Office of Bridges & Structures
FHWA-HIF-19-007

Hydraulic Considerations for Shallow Abutment Foundations

Errata Sheet

December 15, 2020 – version 1.1

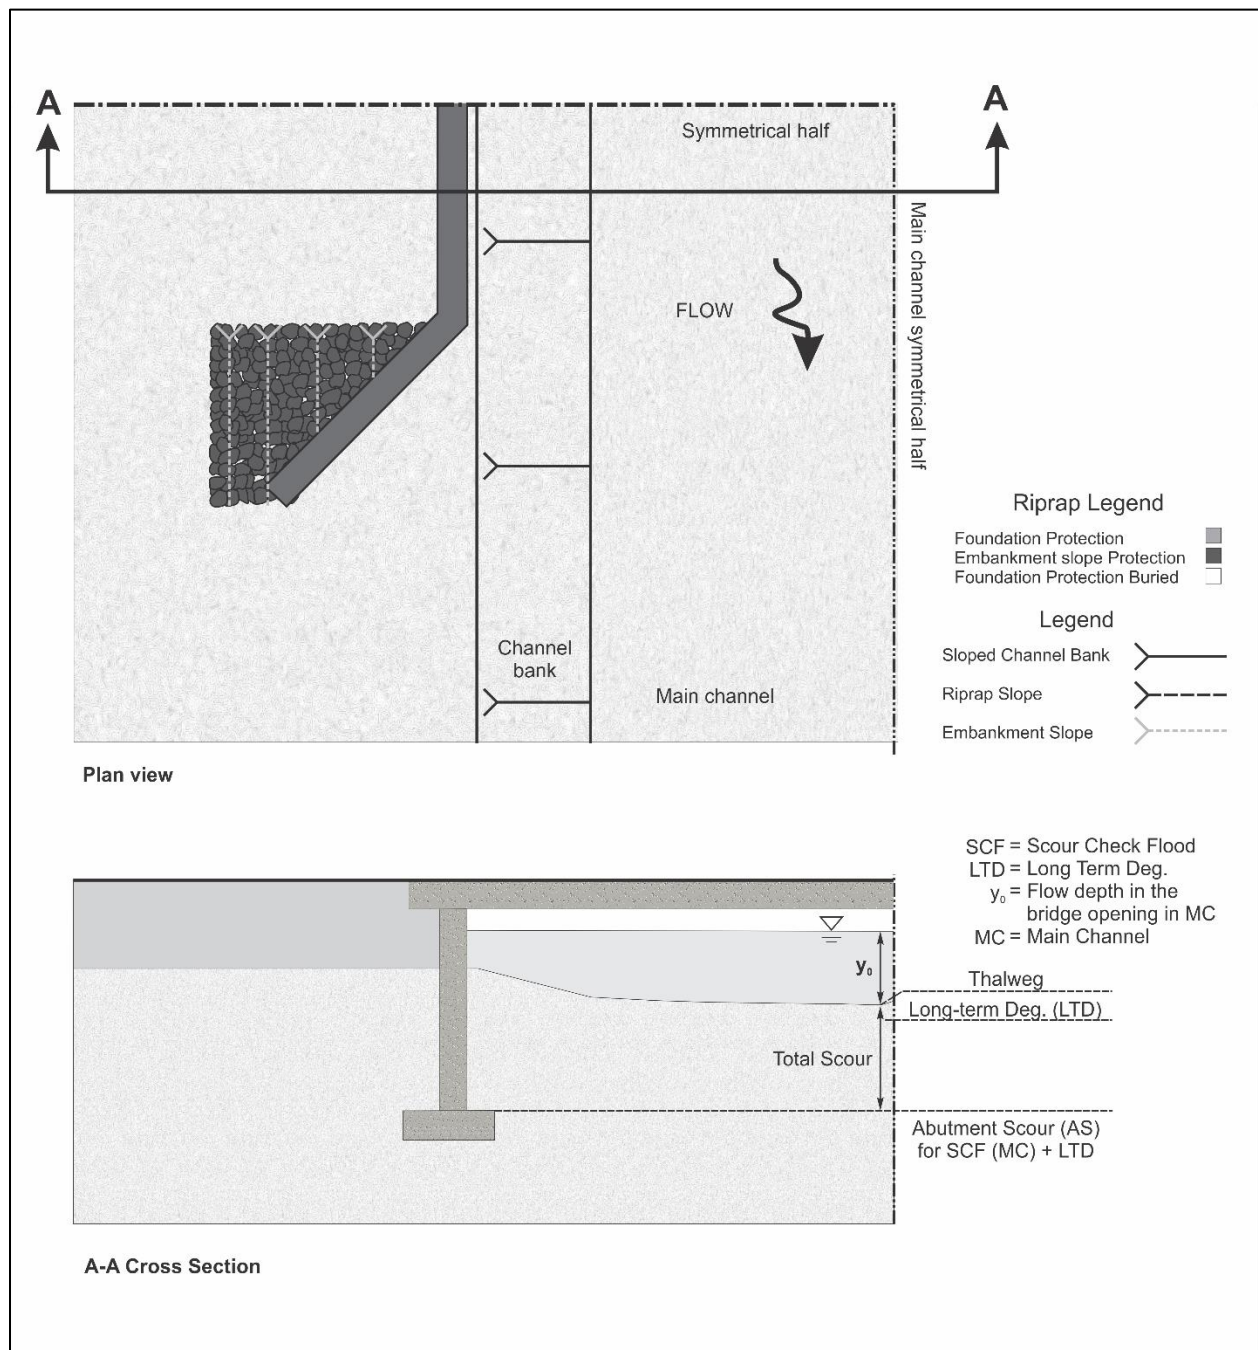
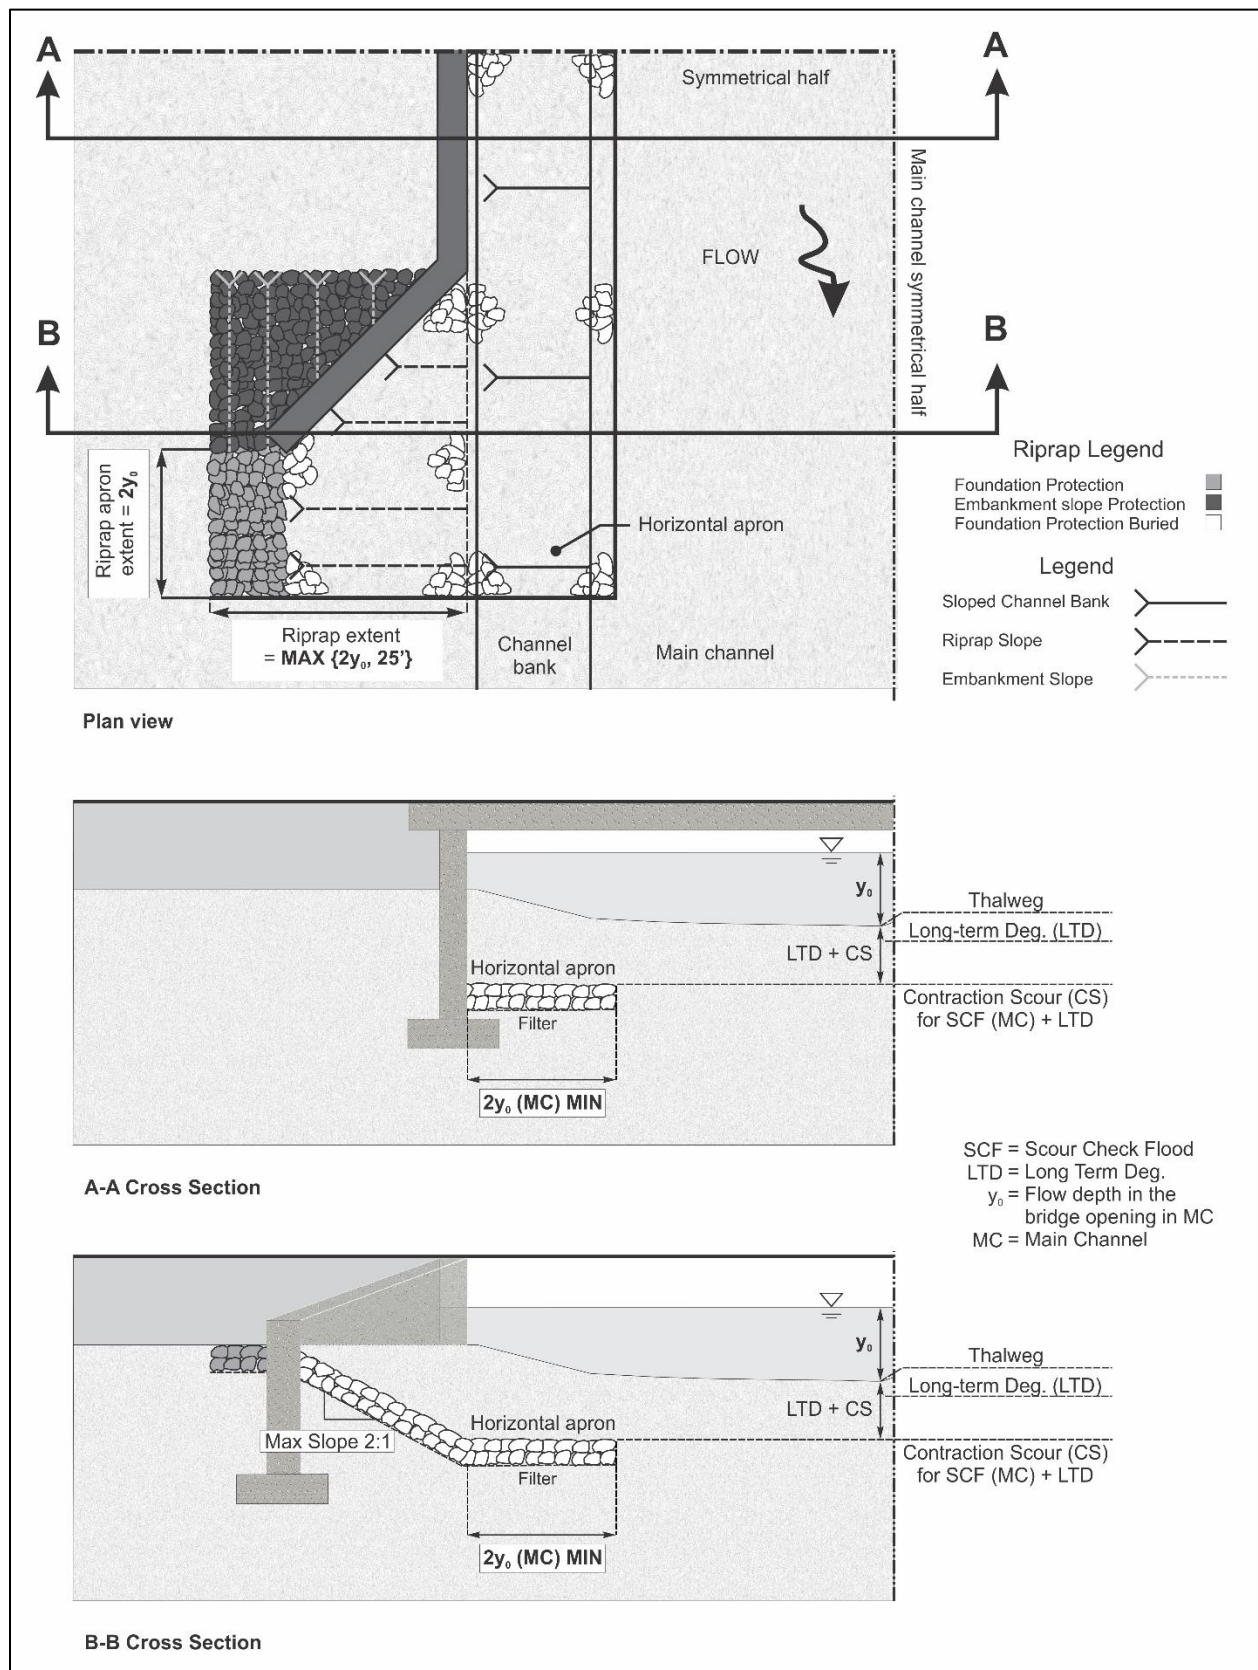
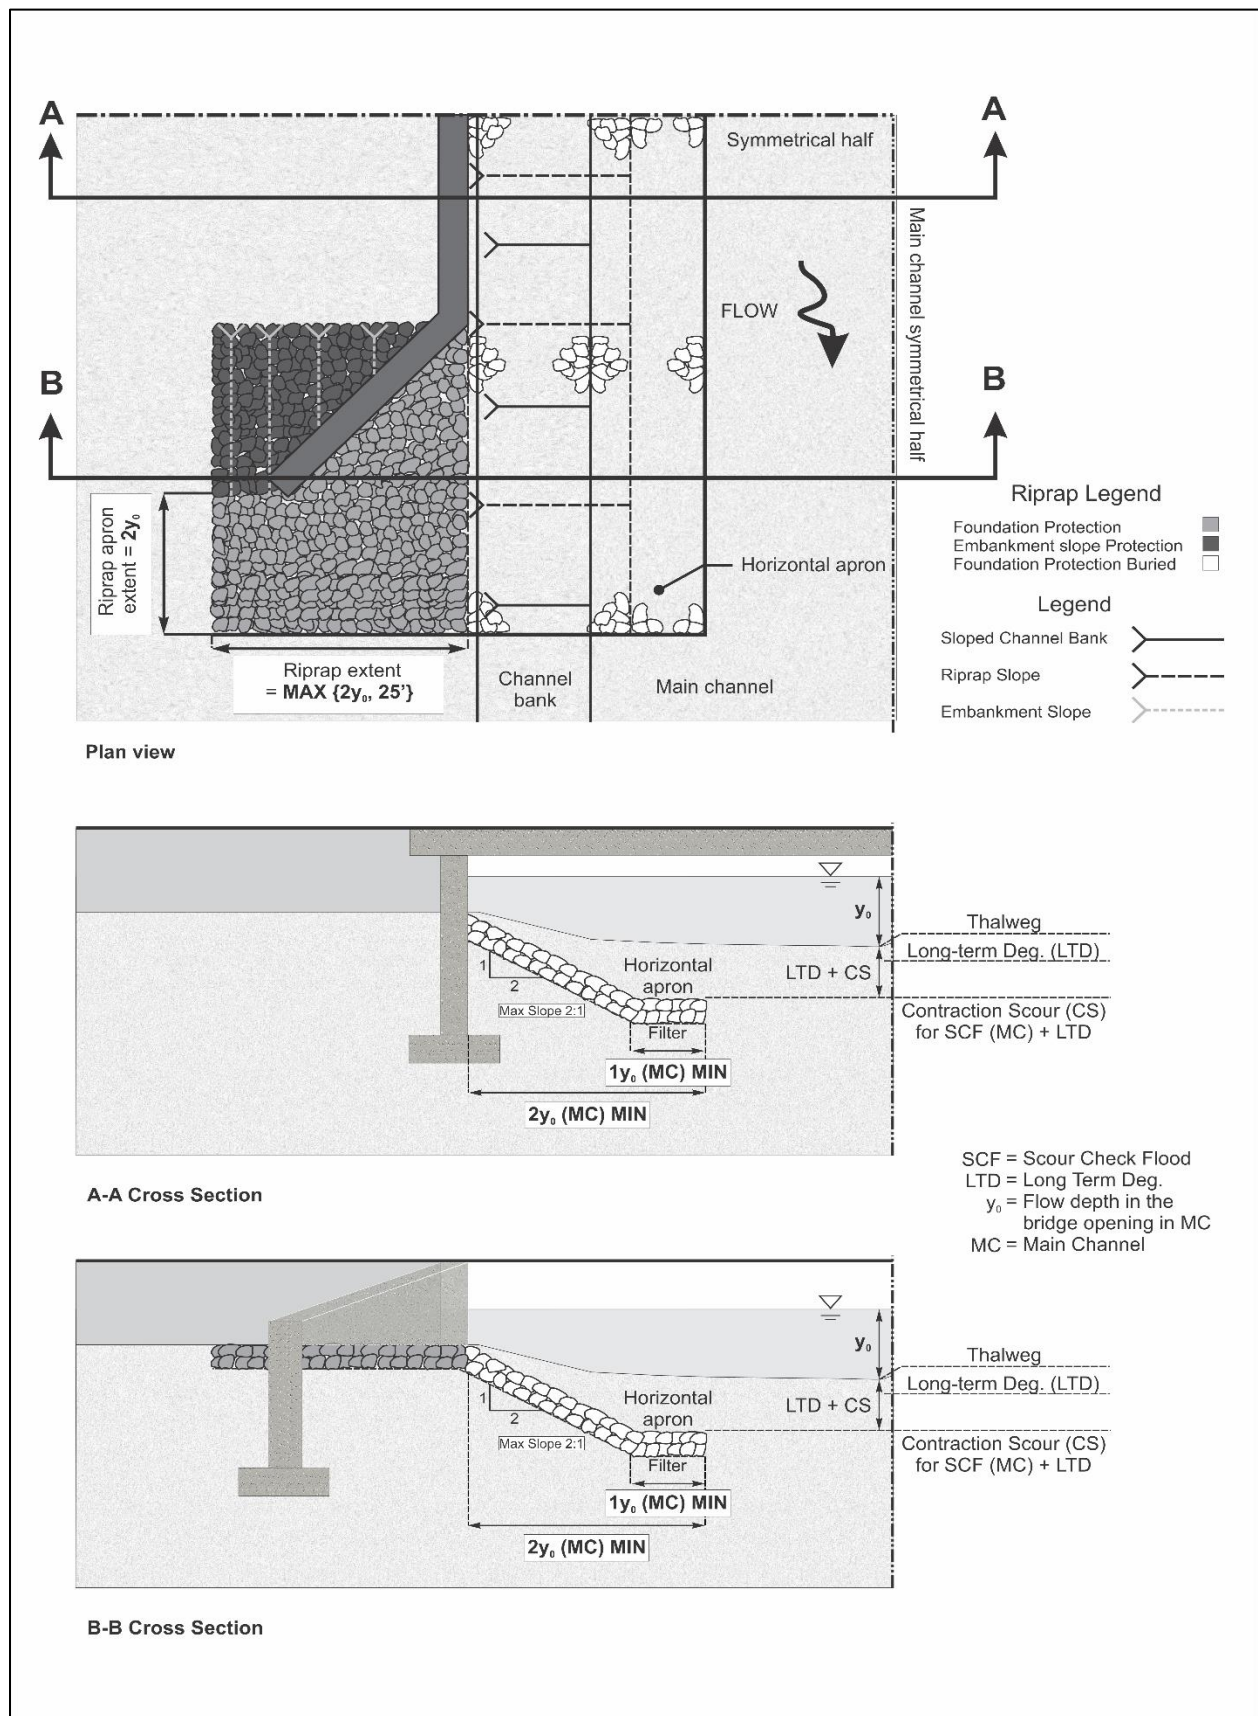
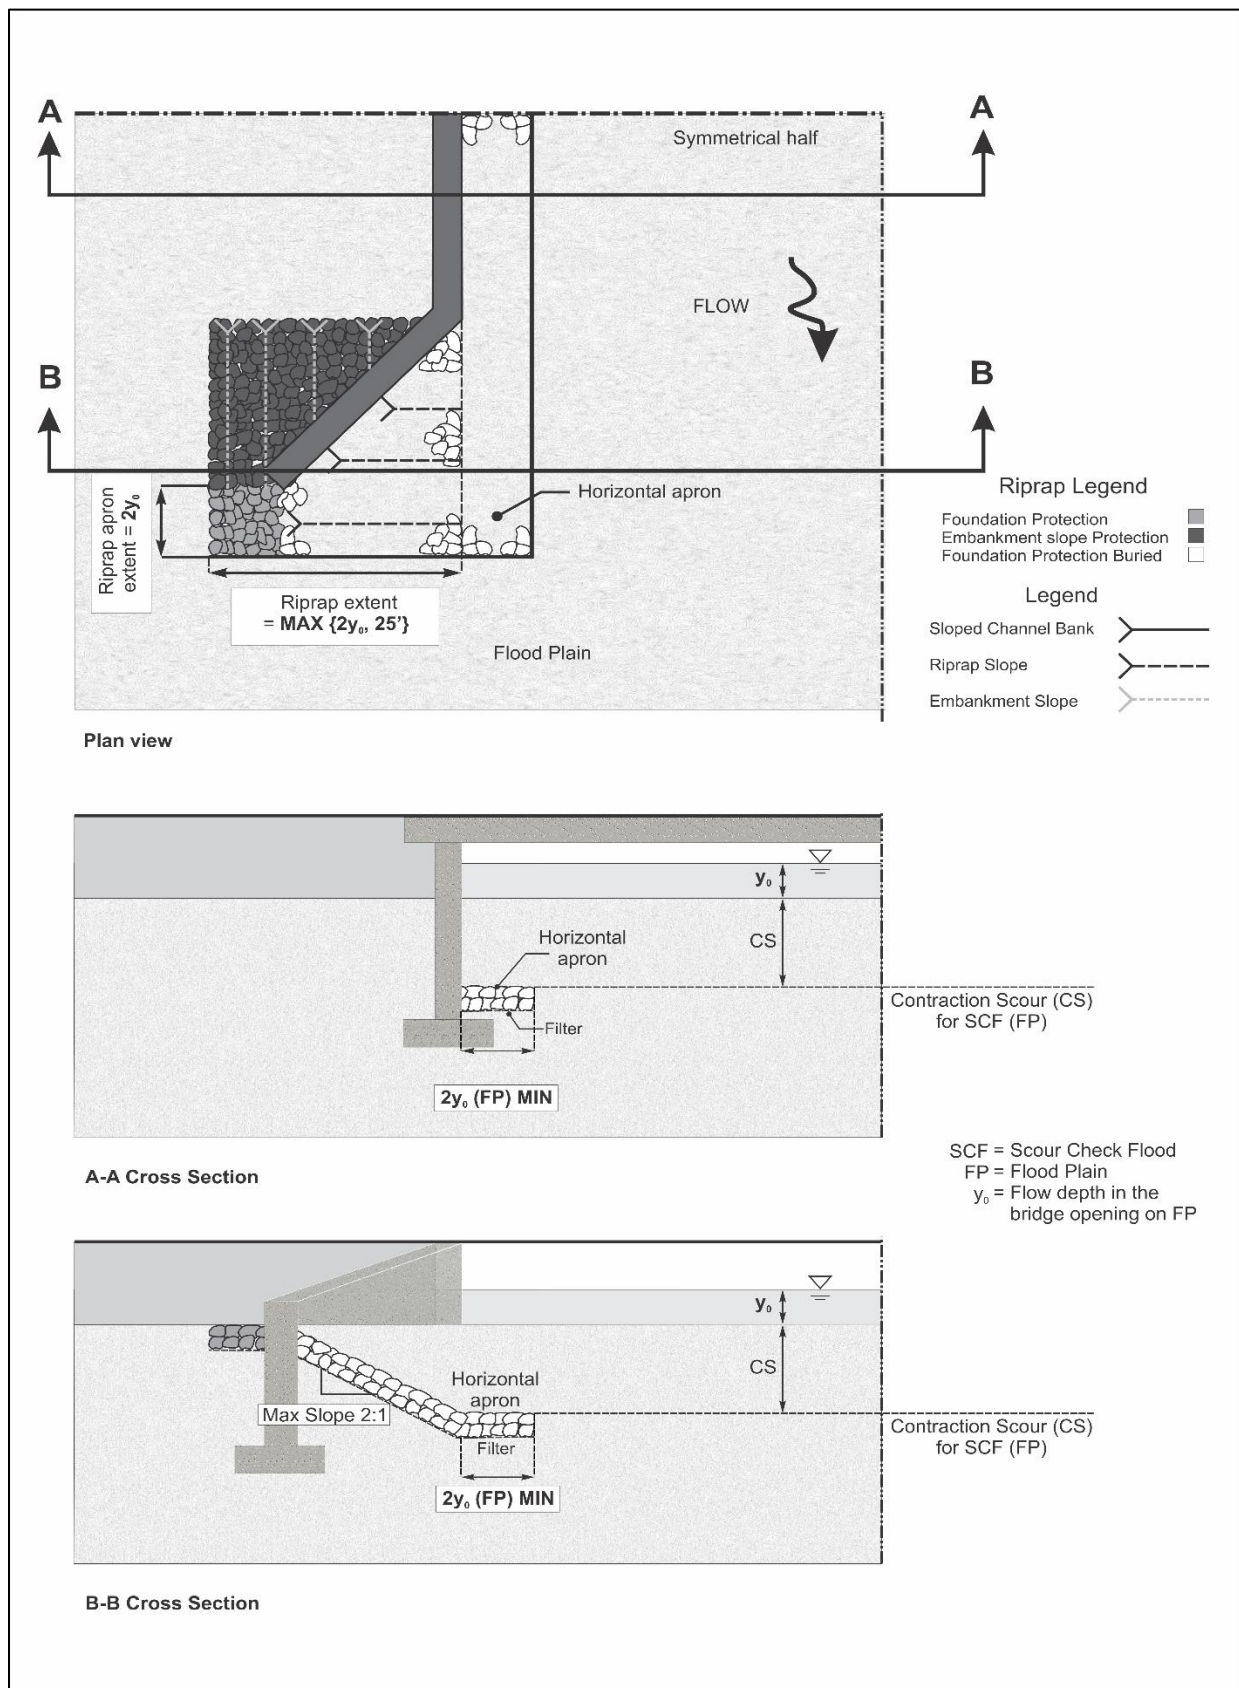
9	7	Language in F) 1. and 2.	<p>Revised to “<i>...(includes any long-term degradation where main-channel hydraulics apply)...</i>”</p> <p>This clarified the distinction of scour considerations for abutments that are near the main channel versus those that are sufficiently set back from the channel.</p>
10	9	Free-Surface Flow 3.a.	<p>Replaced “<i>(either clear-water or live-bed)</i>” with, “<i>(Scour Condition A or B)</i>”.</p> <p>This clarified the use of the NCHRP 24-20 abutment scour conditions.</p>
11	10	Language in Free Surface Flow numbers 2, 3, 4 and Pressure Flow number 1	<p>Revised “<i>Top of footing below countermeasure</i>” to say “<i>Top of footing below countermeasure apron</i>”</p> <p>This clarified the footing placement relative to the countermeasure apron elevation.</p>
12	14	Figure 7, shallow foundation elevation	Revised Figure 7 to lower the shallow abutment foundation to clearly depict that the top of the foundation is below the CS for SCF (MC) + LTD
